ISO SHT. NO. 2161

LIVSEY & COMPANY, INC.
INDIANA & MICHIGAN ELECTRIC CO.
DONALD C. COOK NUCLEAR PLANT

2NSW-116
Lower Containment Ventilation
Unit 1 Return Line

AUX. BLDG.
DWG. NO. 2-NSW-116
REV. 6

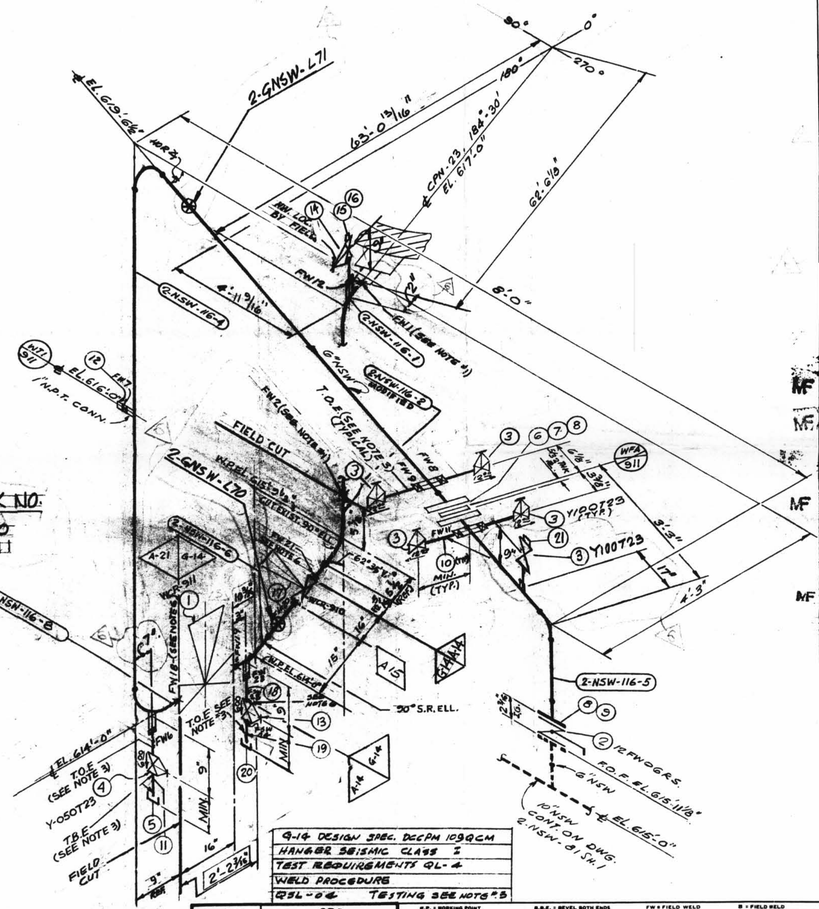
NO.	DATE	DR. CHK	DESCRIPTION	REMARKS
1	1-20-76	DR. B.R.	REVISED BY AEP DESIGN: PER RFC-DC-12-671: ADDED; 6" BW. CONTROL VA., WCR-910, 1/2" DRAIN-VALVE N.S Y-050T36, 1" VENT-VALVE N.S Y-100T36.	ACTION REQ'D.
2	10-25-76	D.V.K. J.B.	REVISED PIPING BY AEP DESIGN.	ACTION REQ'D.
MF 3	4/7/77	WNC	PER RDM-NC-0162 ITEM # 14 WAS Y-100T23. ADDED ITEMS # 15 & 16 TO B/M	
MF 4	9/11/78	A.G. D.R.	PER RFC-DC-12-2549 ADDED: PIPE SPEC. G-14, DIM 'S, PCM K # 6,7,8 & 16, FIELD WELD BOX, NOTES 5, 6 & 7. FIELD WELDS 17 THRU 20. FSW 25 & 25, ITEM NO'S 17 TO 20. REVISED ITEM NO 1 IN B/M, MODIFIED 2-NSW-116-2	FIELD ACTION REQ'D.
MF 5	6/1/81 8/12/82	SG E.G.	PER REC DC-12-2549 BOXED DIM. INDI. FIELD INFO. DIM. 9" WAS 11 1/8", 10 3/16" WAS 11 5/8", 10 5/16" WAS 9 1/8", 5 7/8" WAS 5 3/8", 62° 38" ANGLE WAS 62°4', & RELOCATED FIELD CUT. REVISED ELBOW TO 30° S.R. ELL. DELETED FW 22, 17 AND PC MK. 2-NSW-116-7. ADDED DIM. 5 1/8". W.P. EL. 615'-3 7/8" WAS WREL. 615'-3 5/8".	FIELD ACTION REQ'D.

MF 6	7/21/90	RDM SGM LB	TO REFLECT AS-FOUND CONDITIONS FOR RFC-DC-12-3010 PER FWR # 180 REV. 1 ADDED: 1" VENT & DIMS. & ITEM 21 OF B/M. REVISED: ITEM # 3 & 14 OF B/M TO SUIT. ADDED: SUPPORT MARK NOS. & SUPERSEDES HGR. 150. # 2-GNSW-116.	NO FIELD ACTION REQ'D.
